# Hooper Springs Transmission Project

Final Environmental Impact Statement

DOE/EIS-0451

This document presents the comments received on the Hooper Springs Transmission Project supplemental draft environmental impact statement (EIS) (DOE/EIS-0451, May 2014), Bonneville Power Administration's (BPA's) responses to those comments, and corrections to the supplemental draft EIS. Consistent with the Council on Environmental Quality's (CEQ's) Regulations for Implementing the National Environmental Policy Act (NEPA), this document and the supplemental draft EIS comprise the final EIS for this project because changes in the EIS in response to comments generally involve minor corrections (40 Code of Federal Regulations [CFR] 1503.4(c)). For readers of this document who do not already have a copy of the supplemental draft EIS, copies can be obtained by the following means:

Figure 1. Supplemental Draft EIS Version of Avian Collision Risk Option 3A

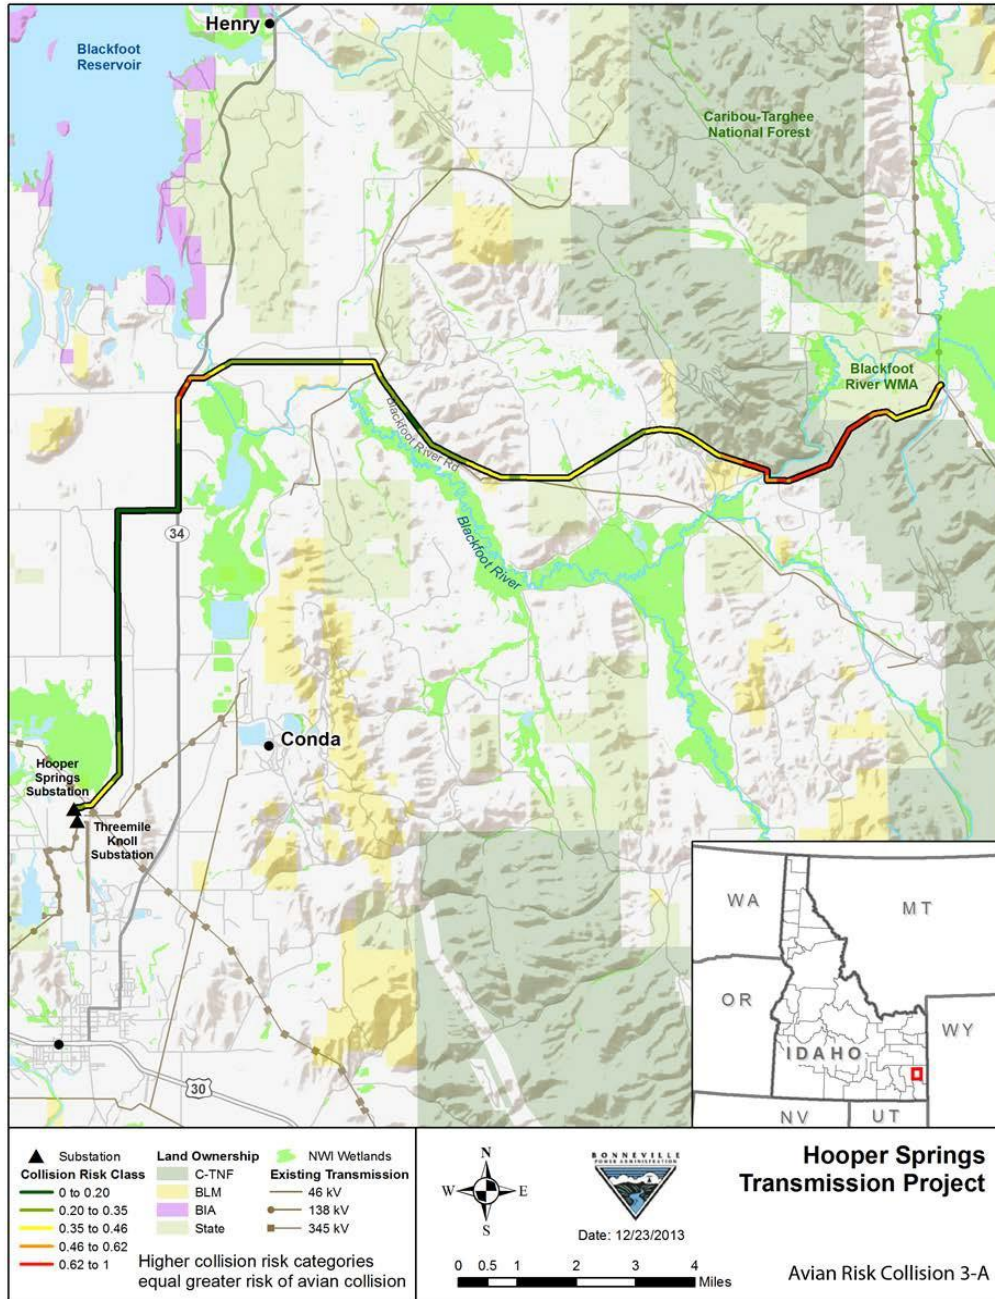
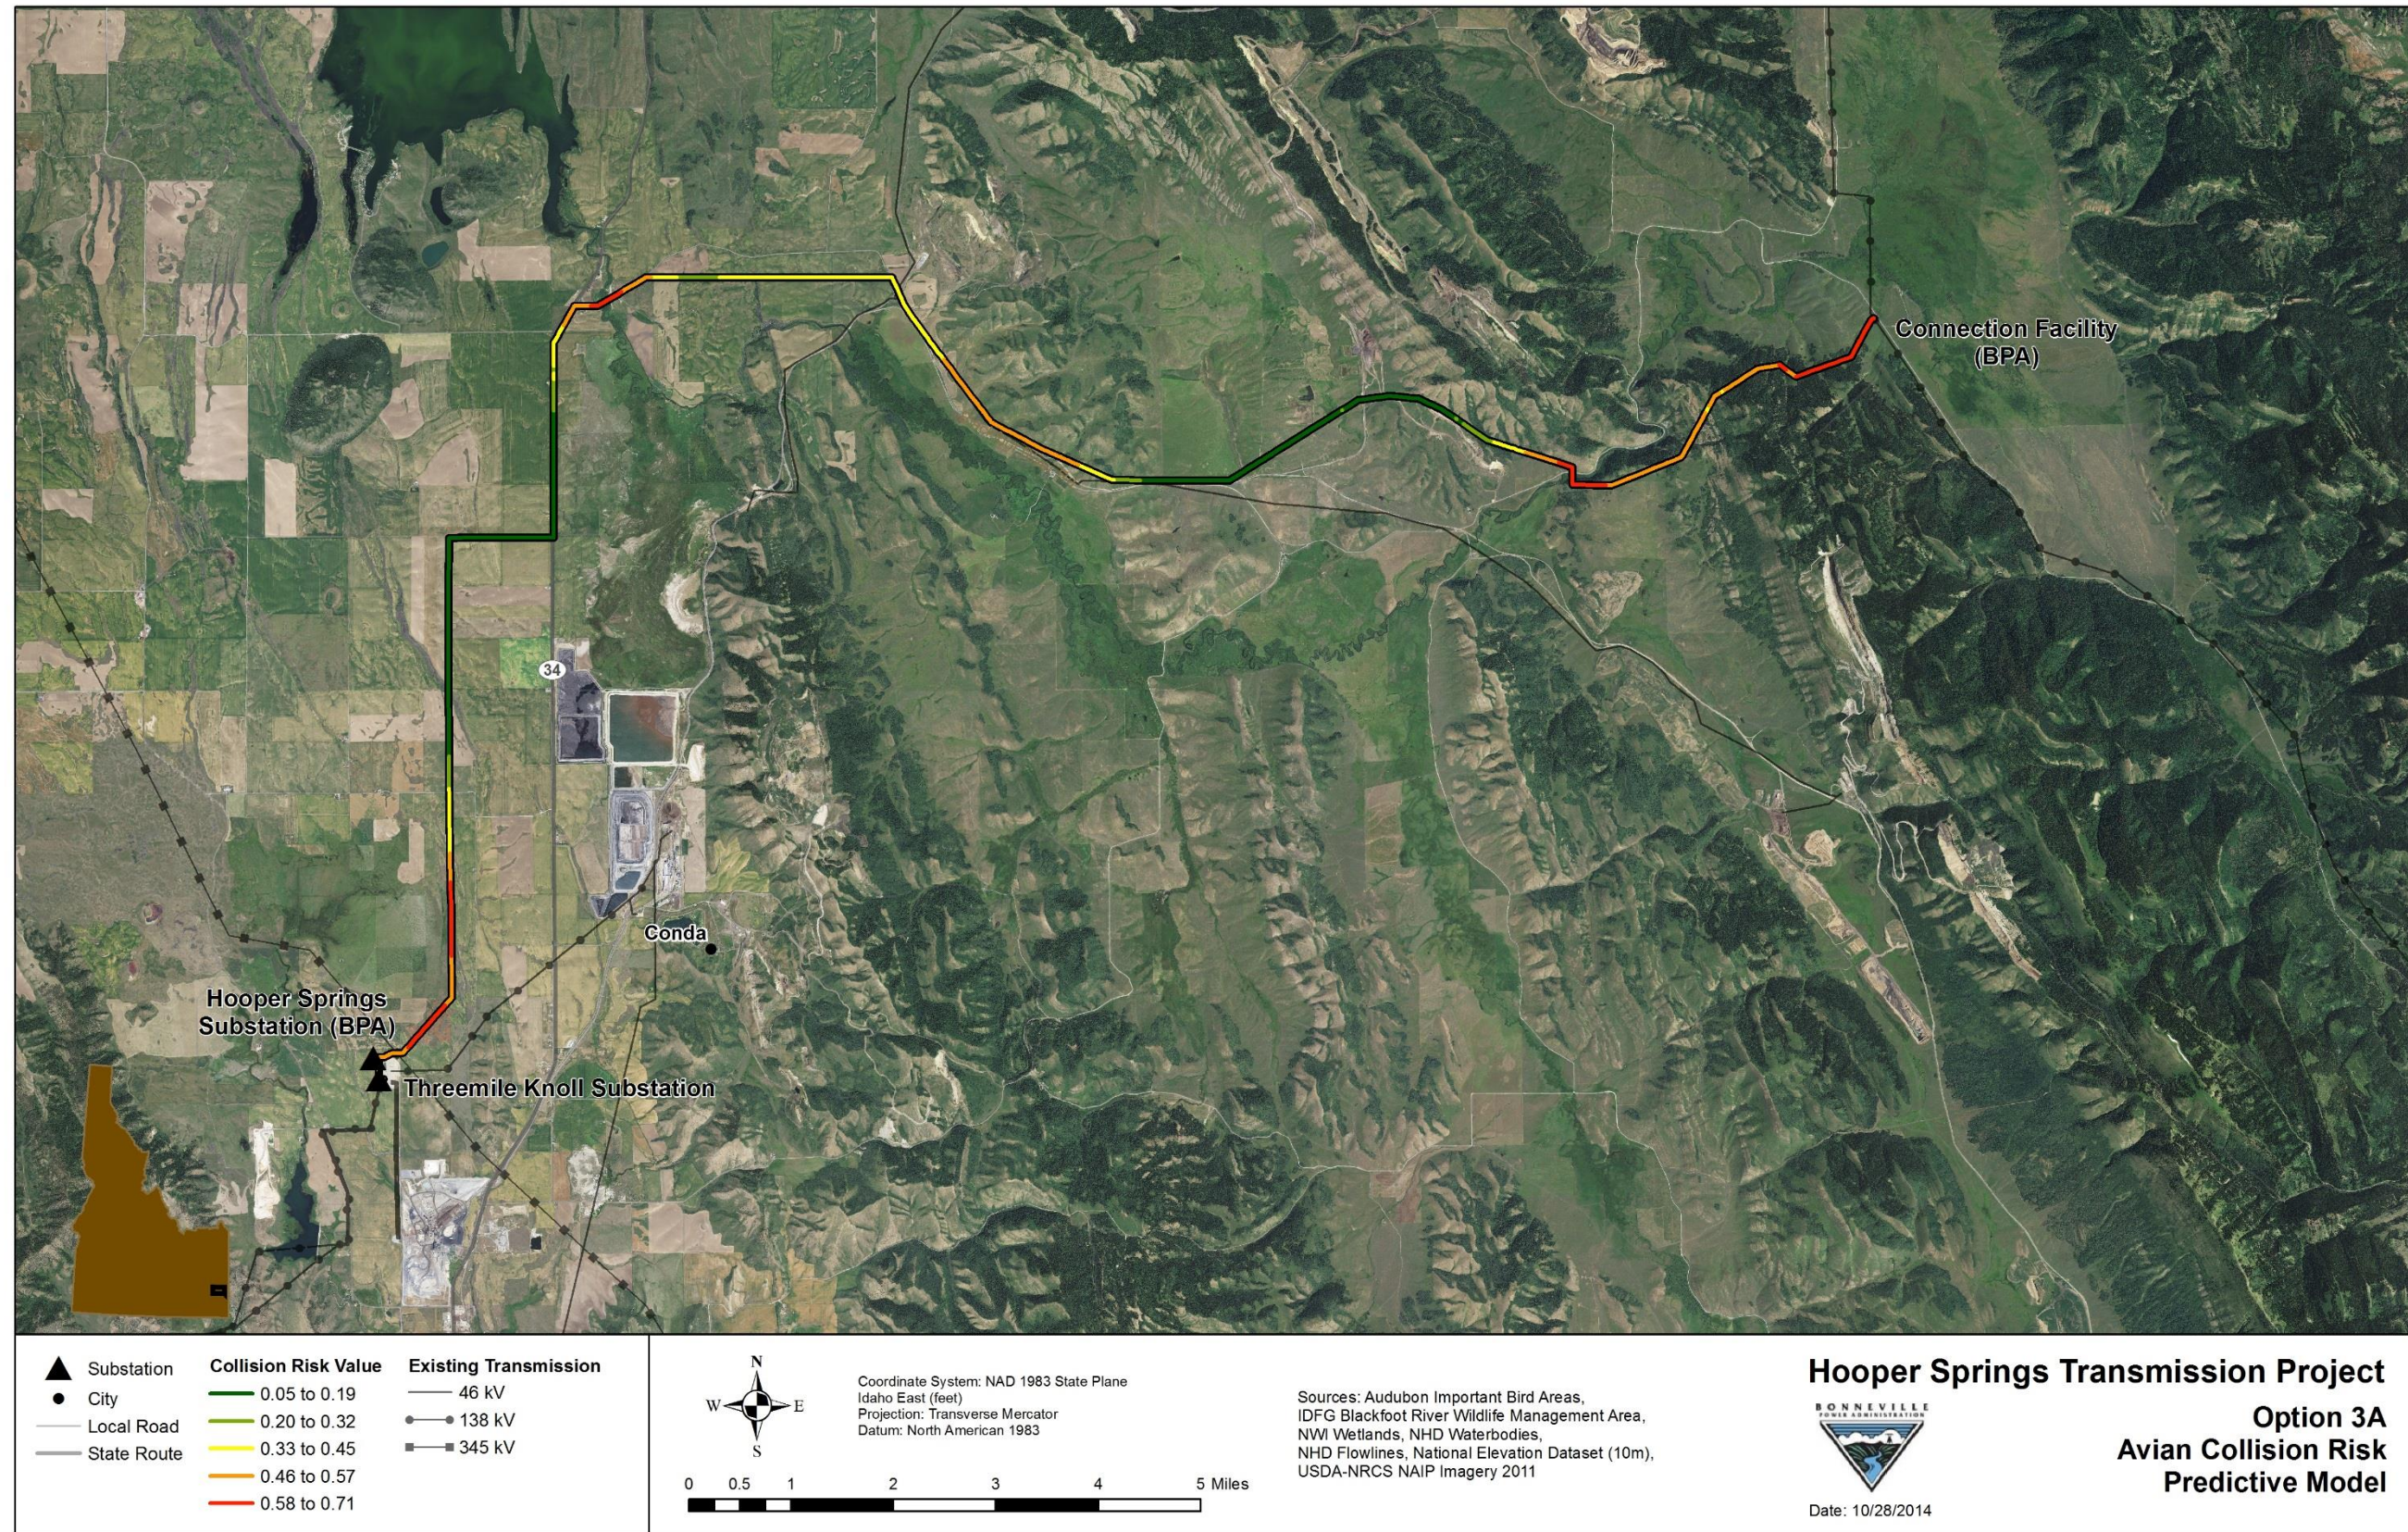
However, based on continued discussions with IDFG and resource surveys allowing for improved data inputs, the model allowed for several modifications that increase model sensitivity and improve overall confidence in model output. Table 2 identifies changes in data used to identify areas of higher collision risk.
